Reference: 22.138r02v01

Re: 14 Prince Alfred Parade, Newport – Proposed Garage and Storage
Response to Request for Information

ATTACHMENT 1

Ground Clearance Assessment

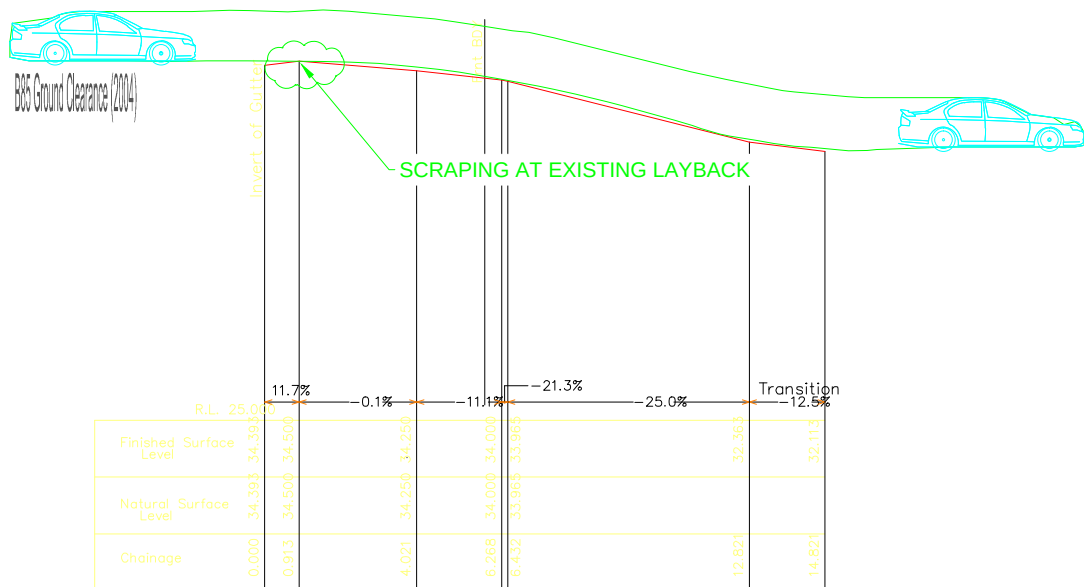
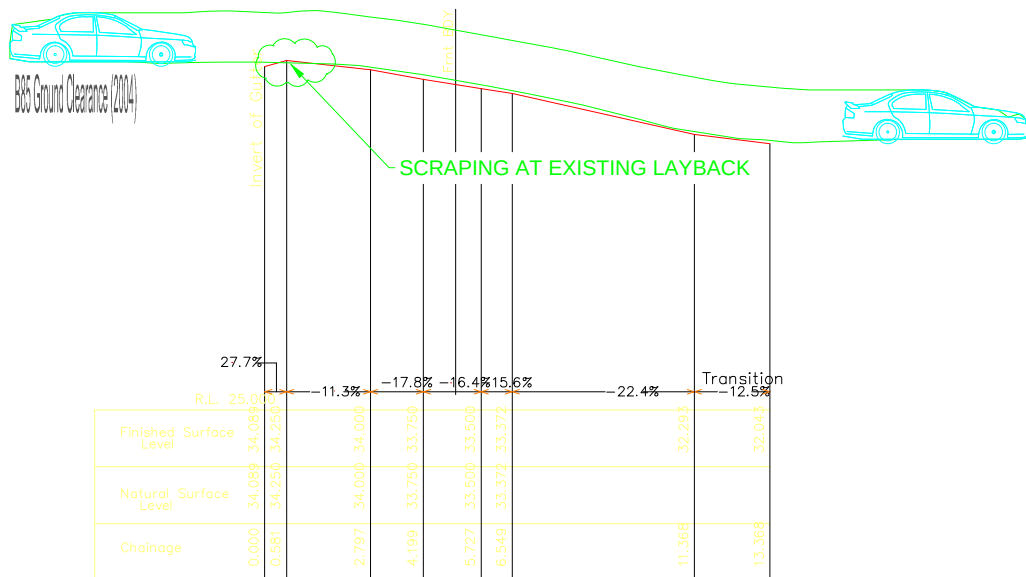
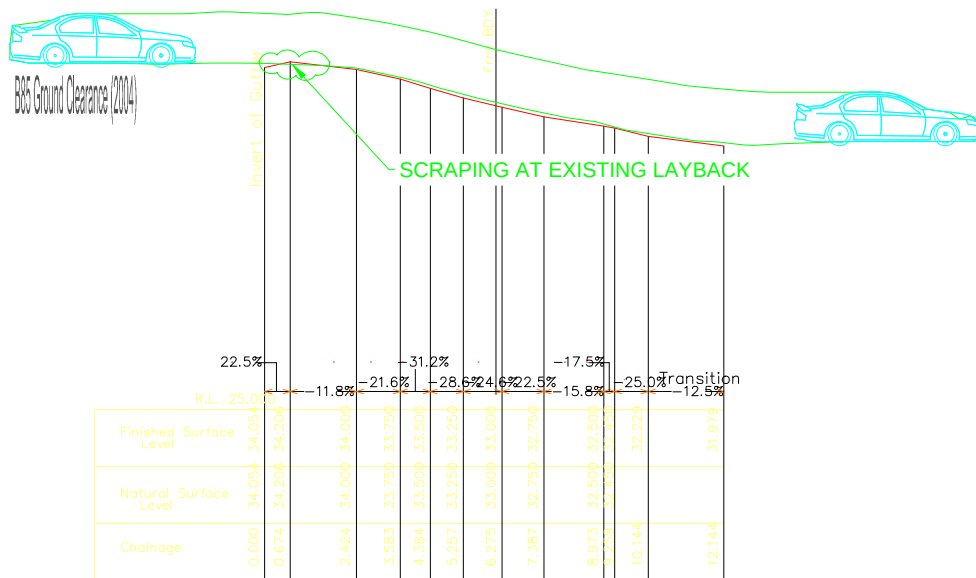
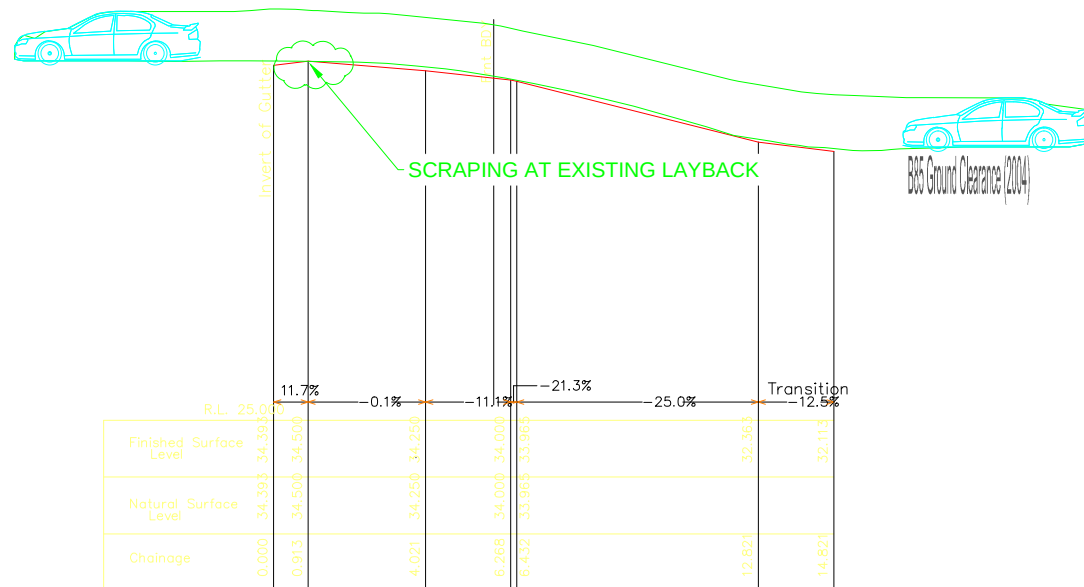
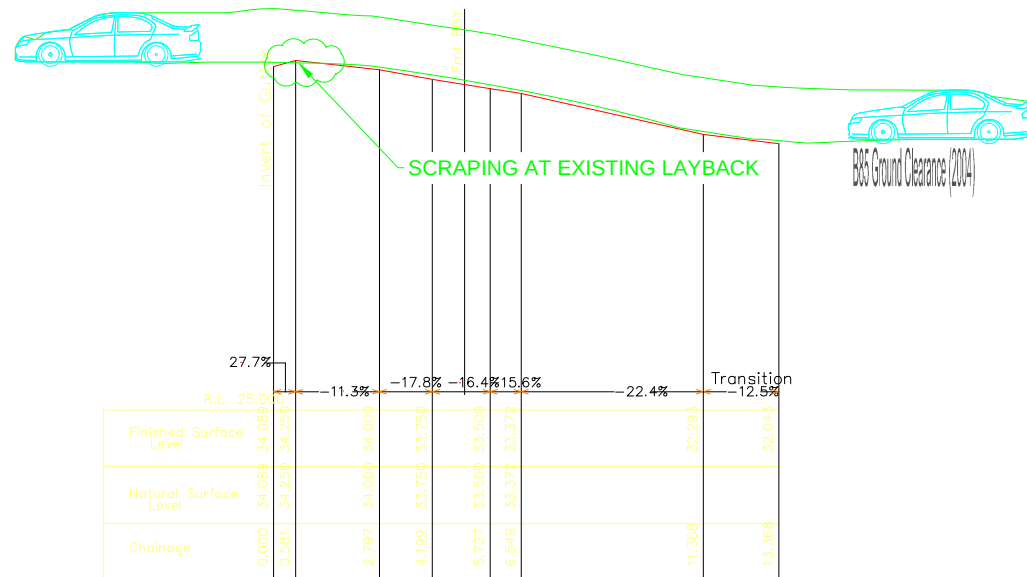
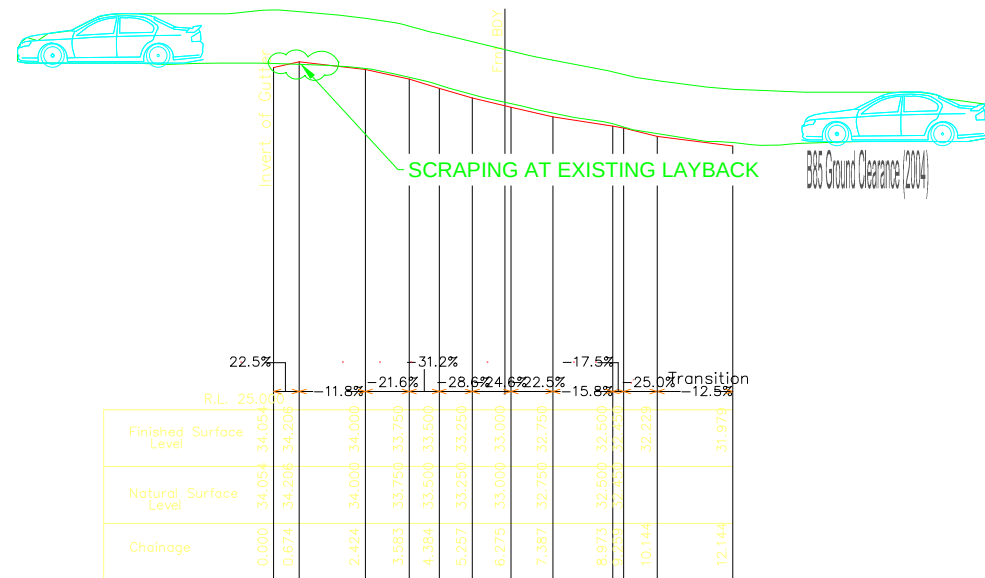
"The application is for the review of DA2021/1682 which involved the construction of an elevated garage and driveway off the exiting ROW. The traffic report and plan by Traffix, dated 1/6/2022 provide sections for the proposed driveway to the proposed garage from the kerb.

However, the concerns raised previously regarding the crossfall across the wheelpath in the transition from the existing ROW to the proposed driveway have not been addressed. The applicant's consultant must demonstrate the safety of the vehicle when entering and exiting the proposed carport. The changing grade between the existing ROW and the new driveway must be in accordance with AS 2890.1."

The ground clearance assessment provided in **Attachment 1** demonstrates no scraping occurs along the existing and proposed driveways within the site. The maximum grade in some locations along the existing driveway does exceed 1:4 (25%) however, Clause 2.6.2 in AS 2890.1 (2004), which specifies the gradients for domestic driveways, allows for grades greater than the maximum in hilly residential locations where 25% may not be practicable. In addition, the maximum average crossfall across the driveway width is 9.5%, which is considered acceptable for a domestic dwelling in a hilly location. Therefore, the proposed driveway extension into the garage complies with the requirements of AS 2890.1 (2004).

Scraping for the B85 design vehicle however does occur at the existing gutter invert which is an existing issue for the development. The proposal to provide a garage with underneath storage does not intensify the use of the driveway. Therefore, the existing gutter invert does not require additional assessment as part of this development application. Only the extension of the driveway into the proposed garage is to be assessed to ensure no scraping occurs for the proposed development, which has been confirmed as compliant above.

Further to the above it should also be noted that the proposed garage addresses an existing safety issue with the existing parking area for 14 Prince Alfred Parade. Currently the parking for 14 Prince Alfred Parade is provided further down the driveway where it is more difficult to see passing vehicles accessing 14A Prince Alfred Parade. This arrangement could occasionally require vehicles to reverse along the driveway to pass. As such, the proposed garage location at the top of the driveway will significantly reduce the potential for conflicting movements with the shared section of driveway limited to the very top of the driveway. It will also eliminate the need for vehicles to reverse along the driveway to pass as visibility for oncoming vehicles in both directions will be significantly improved. Therefore, the proposed garage will significantly improve safety along the driveway reducing the potential for conflicting movements and reversing along the steep curved driveway.
